From: Mark Brooks <Mark@brookscorp.net>
Sent: Monday, March 19, 2018 2:48 PM
To: sbcob
Cc: Patti Stewart (pjsstewart@verizon.net); Hartmann, Joan
Subject: Brooks/Stewart Appeal of the Golden Inn Development Plan Revision
Attachments: 2018.03.19 18-036 Golden Inn Hydro Review.pdf

Subject: Golden Inn and Village Development

Regarding: Hydrologic Review of Pass-Through Storm Water

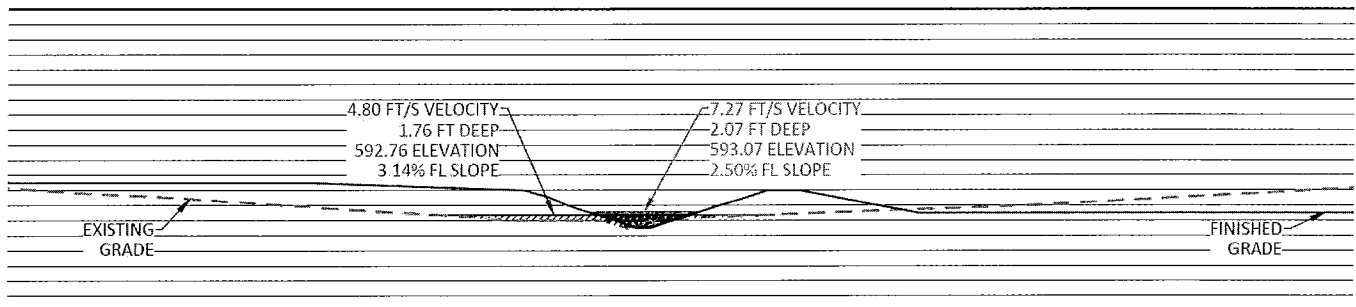
It is assumed that the upstream tributary flows have not changed between the pre and post development conditions, therefore the same flow rate of 125 CFS is used for both cross sections. Flows tributary from the development site are neglected for the purpose of this review.

$Q = 125$ CFS

$Q = 125$ CFS

Velocity = 4.80 Feet per Second

Velocity = 7.27 Feet per Second

Depth = 1.76 feet

Depth = 2.07 feet

It is my professional opinion that the project grading modified the drainage course for pass-through flows by modifying a previously meandering flow line to a more defined drainage channel. In doing so, the flow characteristics of the pass-through flow were changed. As noted above, for a 25-year event, the depth of flow increased by approximately 18 percent. For the same event, the velocity of the flow increased 51 percent.
